# HISTORIC AND DESIGN REVIEW COMMISSION

**HDRC CASE NO:** 2023-022  
**ADDRESS:** 102 MUNCEY  
**LEGAL DESCRIPTION:** NCB O1668 BLK L LOT S 52.5 FT OF 15 & 16  
**ZONING:** R-5, H  
**CITY COUNCIL DIST.:** 2  
**DISTRICT:** Dignowity Hill Historic District  
**APPLICANT:** Virginia Berk/BERK VIRGINIA R  
**OWNER:** Virginia Berk/BERK VIRGINIA R  
**TYPE OF WORK:** Exterior and fenestration modifications, rear addition, window replacement, fencing, driveway installation,  
**60-DAY REVIEW:** Not applicable due to City Council Emergency Orders  
**CASE MANAGER:** Edward Hall  
**REQUEST:**

The applicant is requesting a Certificate of Appropriateness for approval to:

**1 SITE PLAN**  
N.T.S.

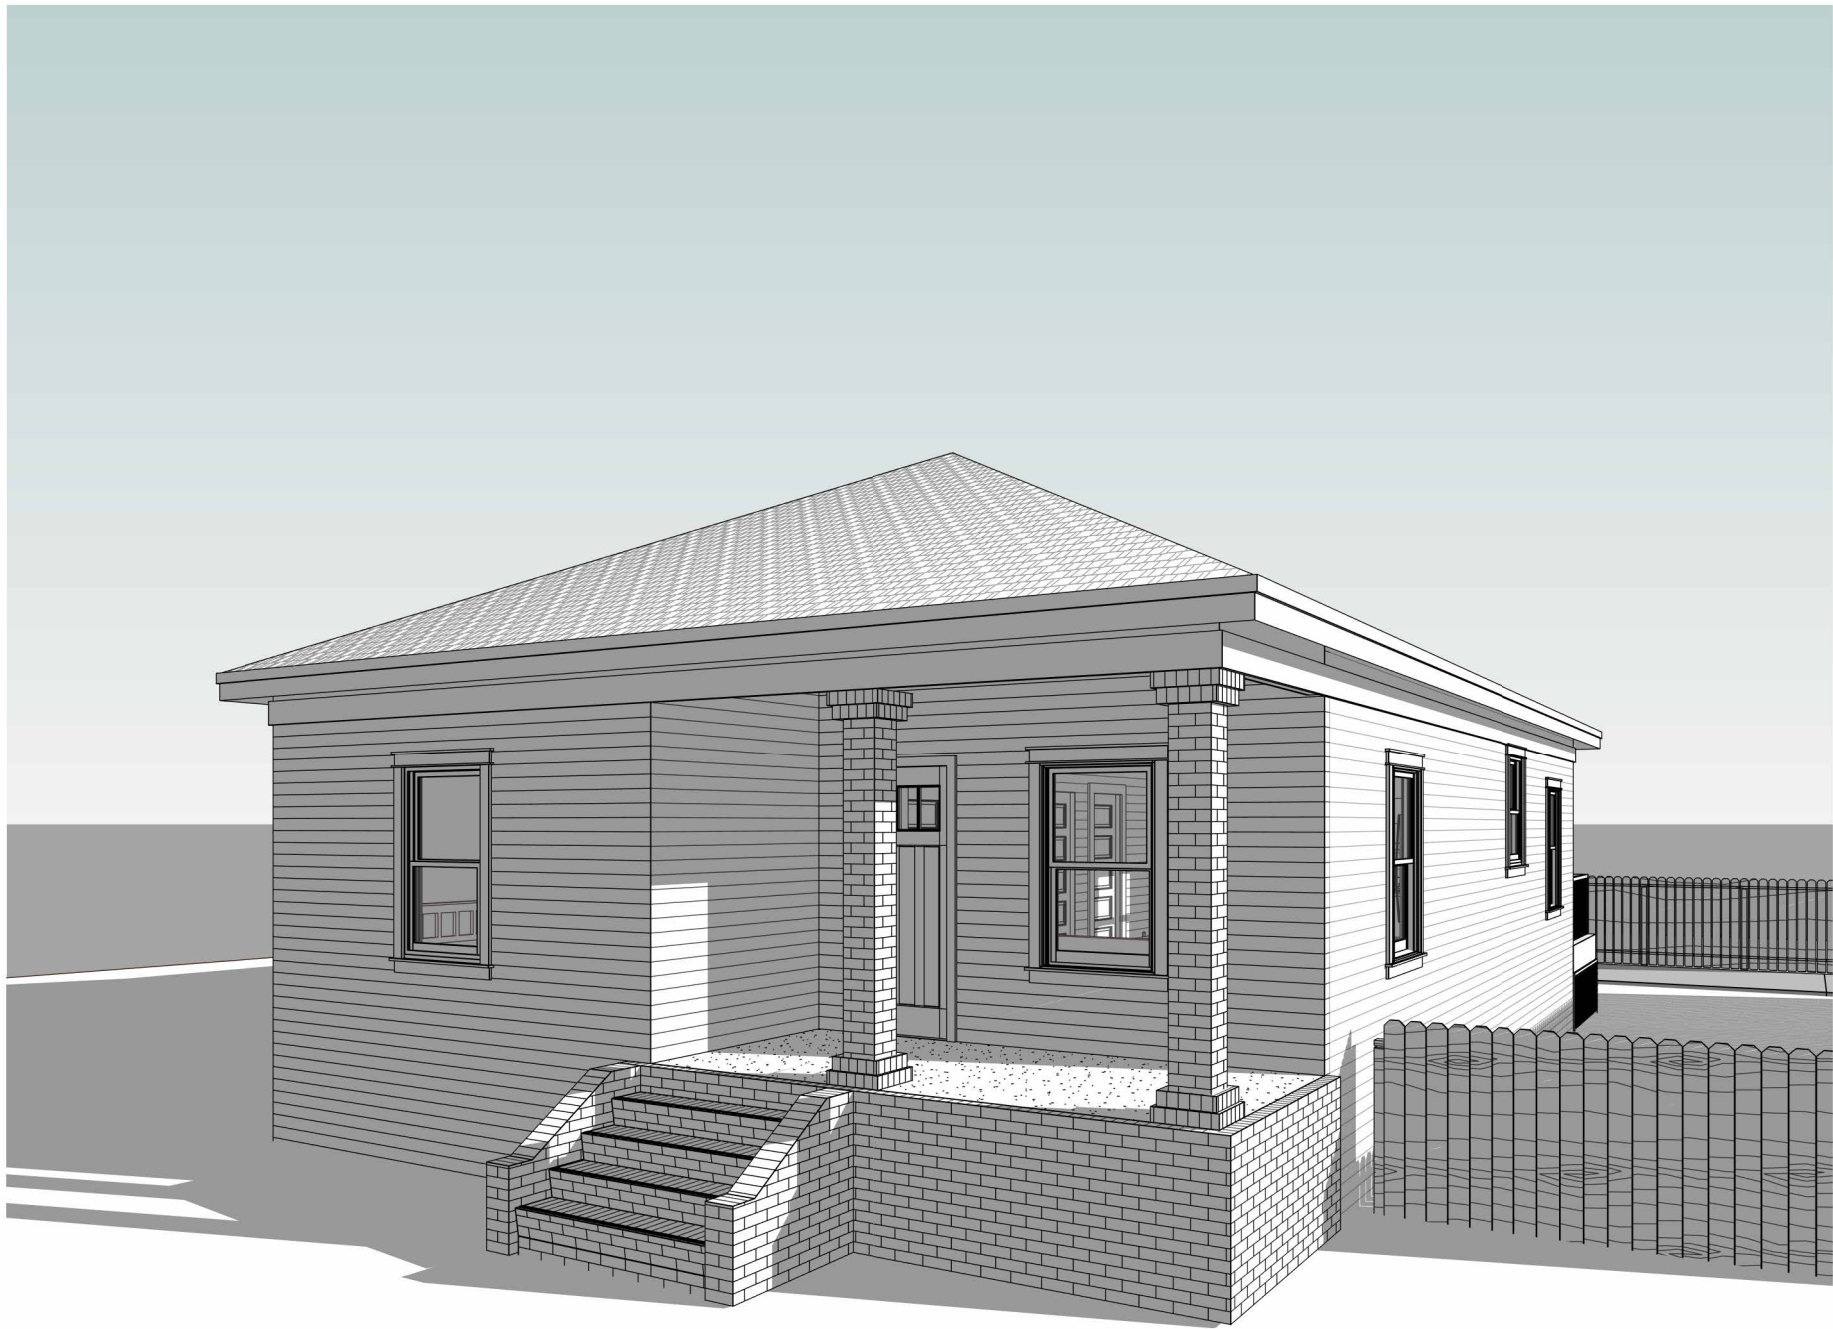
- m. DRIVEWAY – The applicant has proposed to install a concrete driveway at the rear of the lot to facilitate automobile access from Gorman Street into the rear yard and to the proposed garage addition. The curbcut and apron for the proposed driveway currently exist. The applicant has not noted a total width of the driveway at this time. Generally, staff finds the proposed driveway location to be appropriate; however, the driveway should not exceed ten (10) feet in width, per the Guidelines for Site Elements.

7. Staff recommends approval of item #7, the installation of a rear yard driveway with the following stipulation:
  - i. That the driveway not exceed ten (10) feet in width, per the Guidelines for Site Elements.

1 NEW WORK FLOOR PLAN

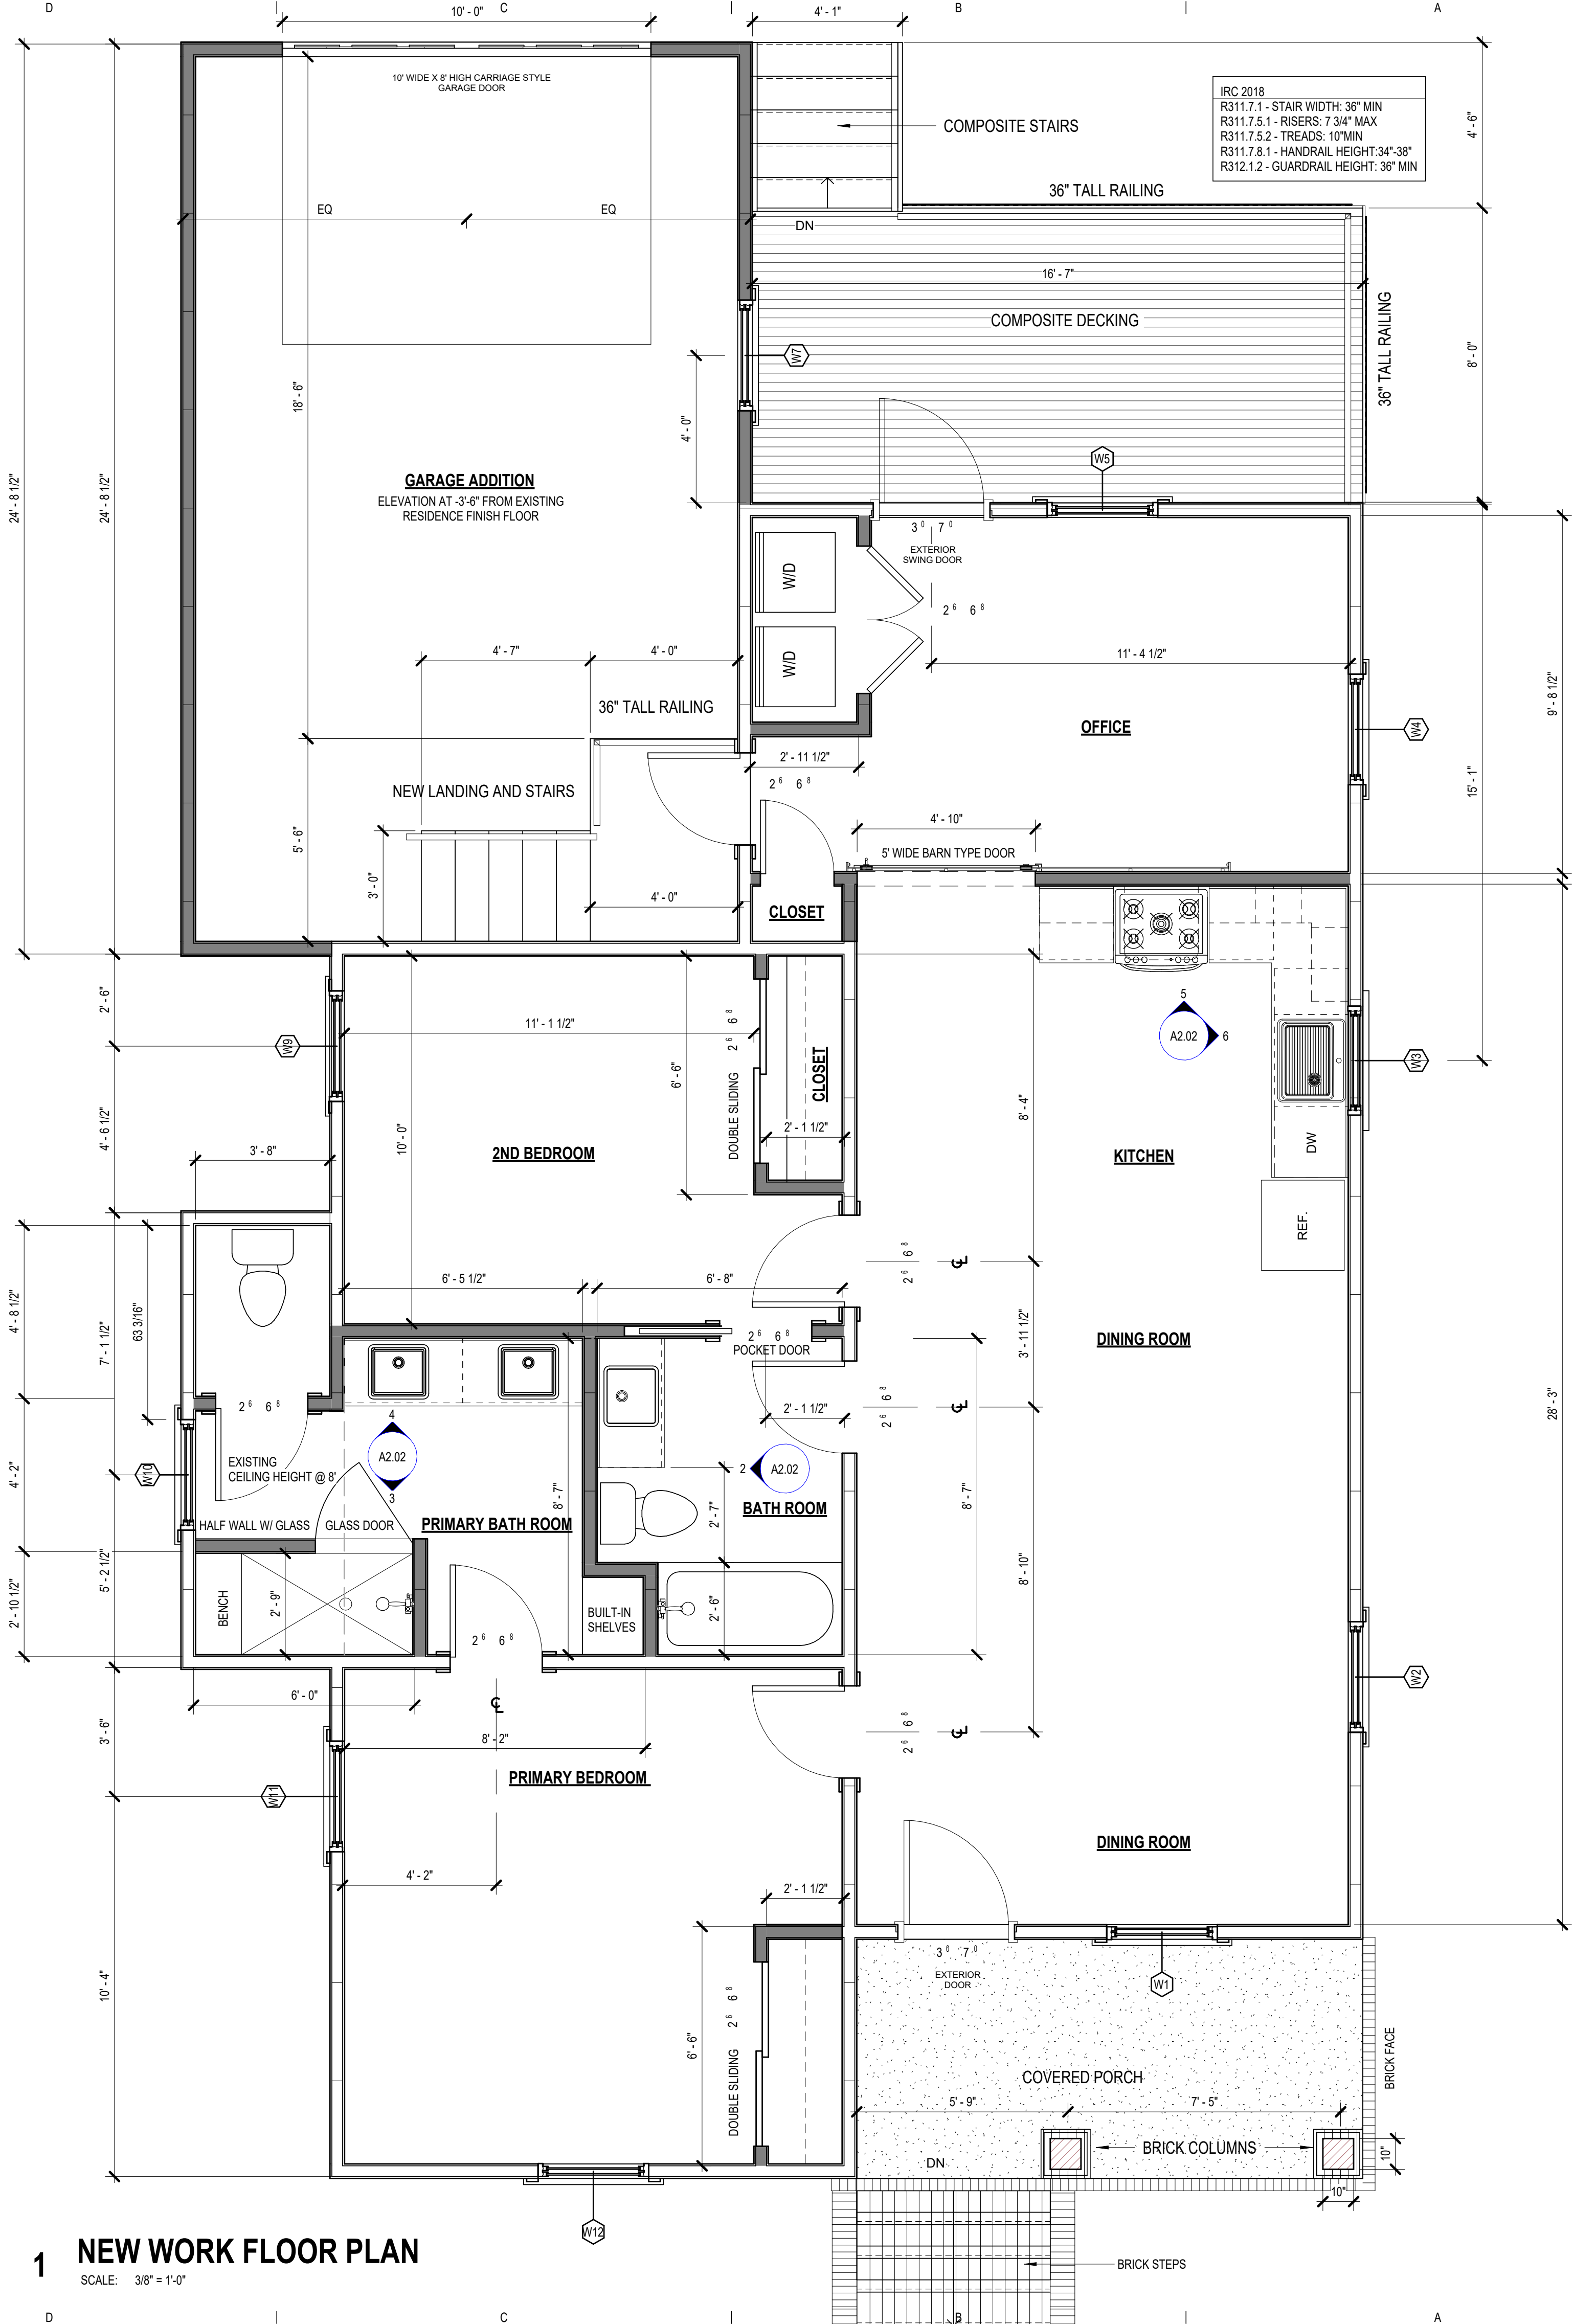
- e. WINDOW REPLACEMENT – The applicant has proposed to replace the existing, non-original aluminum windows with vinyl windows. Staff finds that wood or aluminum clad wood windows should be installed that are consistent with the adopted policy document. As noted in finding b, previously modifications to the structure’s fenestration pattern have resulted in window openings that are not the size of the original. Staff encourages the applicant to introduce windows in as many original locations as possible.

- 3. Staff does not recommend approval of item #3, the replacement of existing, non-original windows with vinyl windows, as noted in finding e. Staff recommends that windows be installed that are consistent with the adopted window policy document. Additionally, staff encourages the applicant to introduce windows in as many original locations as possible.

**EXTERIOR ELEVATIONS**

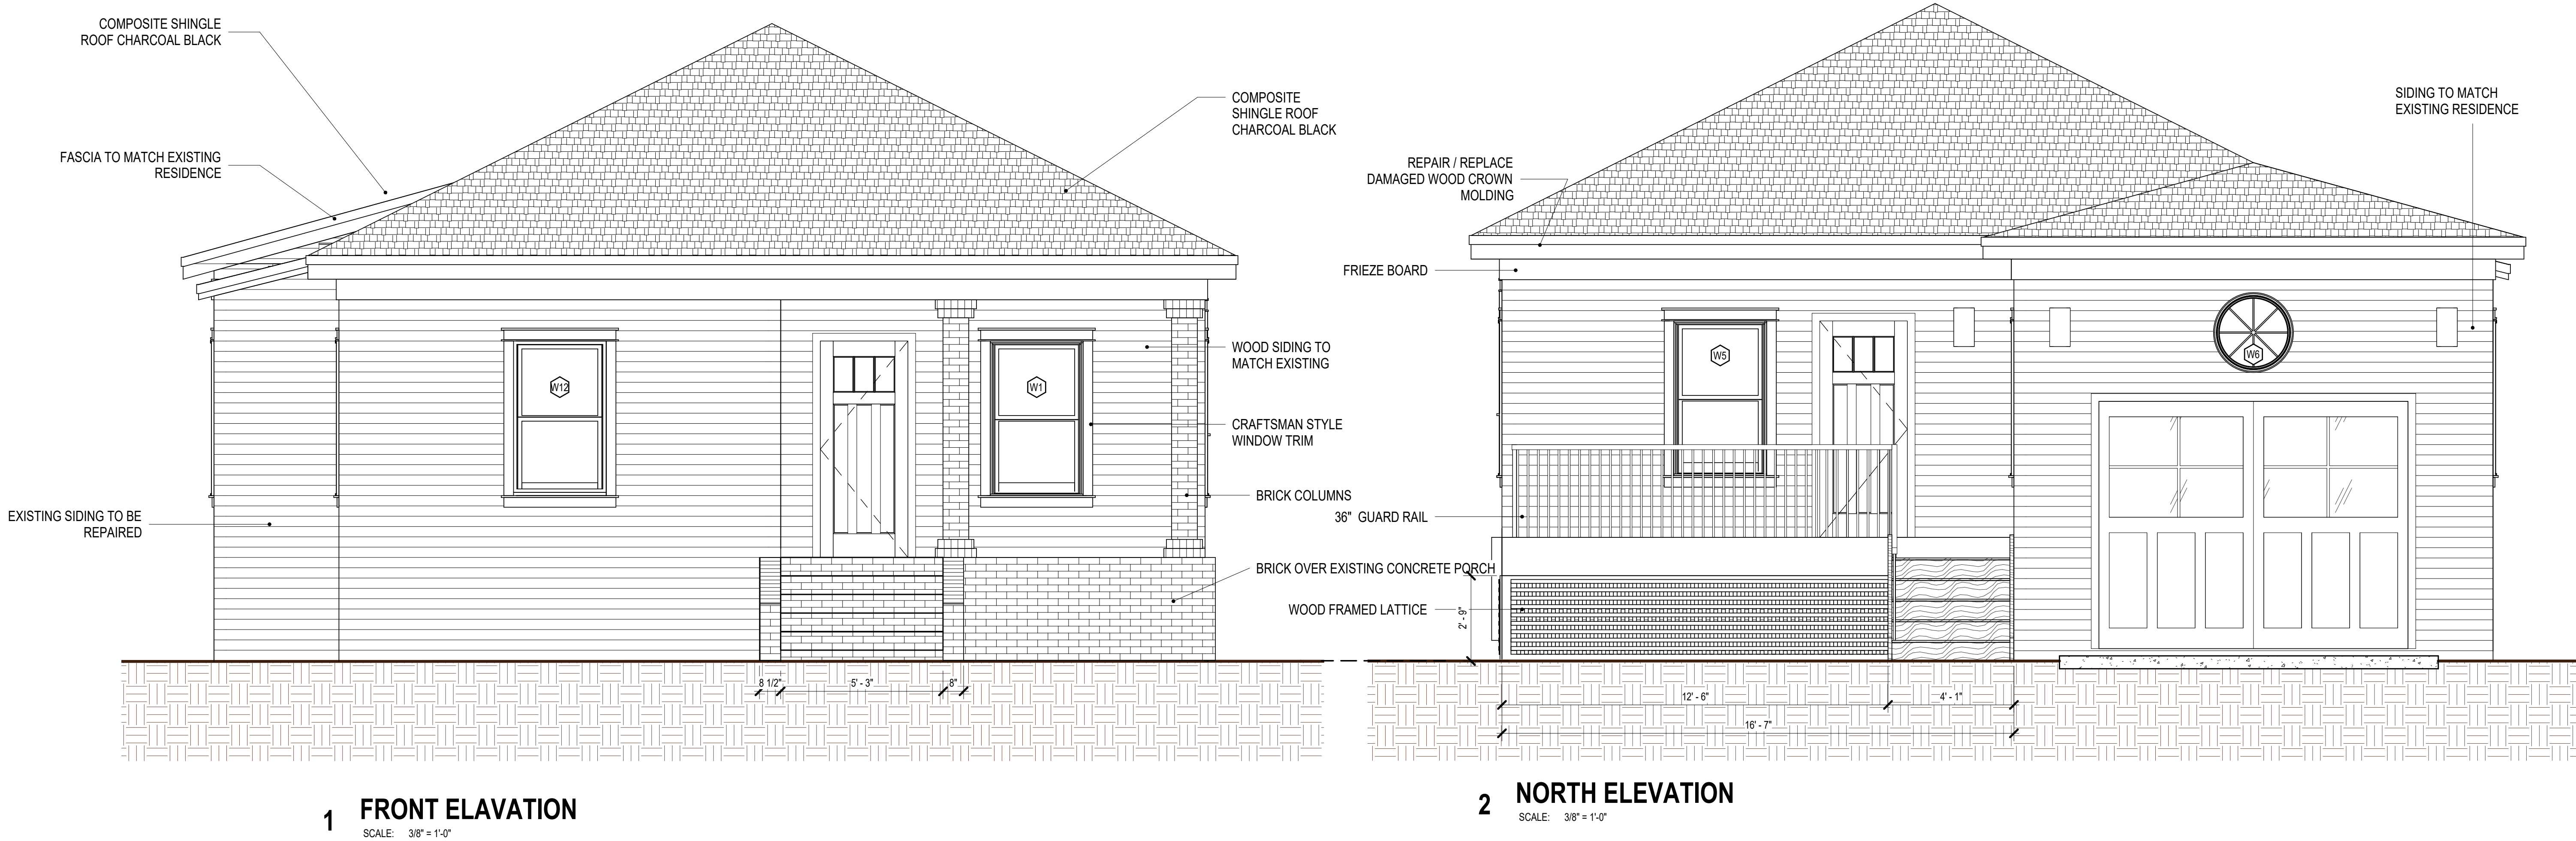
- g. PORCH MODIFICATIONS – The applicant has proposed to install brick over the concrete front porch and to replace the existing, wrought iron columns with brick columns. The Guidelines for Exterior Maintenance and Alterations 7.B. notes that porches should be reconstructed based on accurate evidence of the original, such as photographs. When no evidence exists, the design of reconstructed porches should be based on the architectural style of the building. Additionally, the Guidelines note that elements that create a false historic appearance should not be added. Staff finds the proposed brick columns and skirting to be inconsistent with the Guidelines. 6x6 wood columns with tapered corners and capital and base trim would be most appropriate.

5. Staff recommends approval of item #5, front porch modifications based on finding g with the following stipulations:
  - i. That the proposed brick columns, skirting and porch steps be eliminated.

- ii. That the applicant install wood columns that are six (6) inches square, with chamfered corners and capital and base trim.
6. Staff does not recommend approval of item #6, the construction of an attached garage, based on findings h though l. Staff recommends the applicant construct either a detached garage as found historically within the district.
